Fix to UCLA Ready Line

Wiring Changes

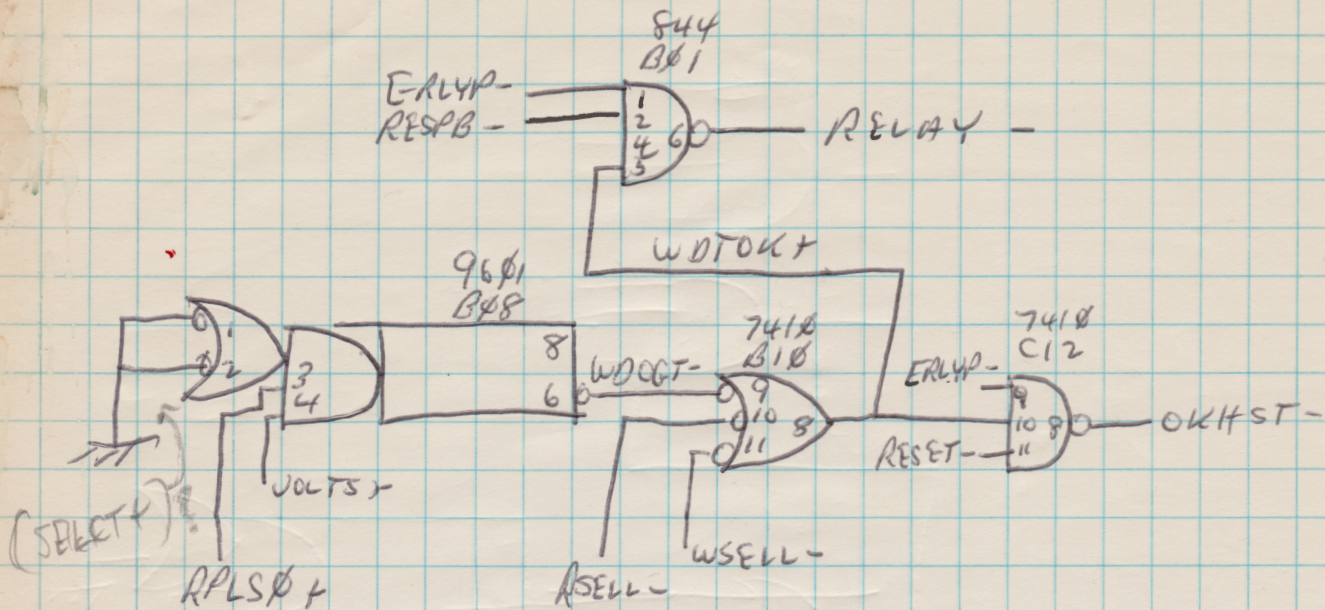
delete	B08 08	-	C 12 10	2	WDOGT+
delete	B01 05	-	B08 08	1	WDOGT+
add	B10 08	-	B01 05	1	WDTOK+
add	B10 08	-	C 12 10	2	WDTOK+
add	B08 06	-	B10 09	1	WDOGT-
delete	A18 12	-	A30 03	2	SELECT+
delete	A30 03	-	B08 03	1	SELECT+
add	A18 12	-	A30 03	2	SELECT+
add	B08 03	-	B 18 05	2	RPLSD+
delete	A16 09	-	B19 08	2	RSEL-
add	B19 08	-	B10 10	1	RSEL-
add	A16 09	-	B10 08	2	RSEL-
add	C20 13	-	B10 11	2	WSEL-

delete	WDOGT+	
add	WDTOK+	
	B10 08	- B 01 05 1
	B10 08	- C 12 10 2
add	WDOGT-	
	B08 06	- B10 09

delete	SELECT+	
	A3003 - B0803	1
add	RPLSD	
	B0803 - B1805	2
add	RSELL-	
	B1908 - B1010	1
add	WSELL-	
	C2013 - B1011	2

change	B0105	WOTOK+
change	B0803	RPLSD+
delete	B0806	WDOGT-
delete	B0808	
add	B1008	WOTOK+
add	B1009	WDOGT-
add	B1010	RSELL-
add	B1011	WSELL-
change	C1210	WOTOK+

B10 - 7410 change to F

Note: Timing for 9601 can be any reasonable interval. Ready line will stay up while an operation is selected and for m seconds after RPLSD ~~ends~~ ~~there~~ fires where m is the length of WDOGT. Two seconds is perhaps quite reasonable.
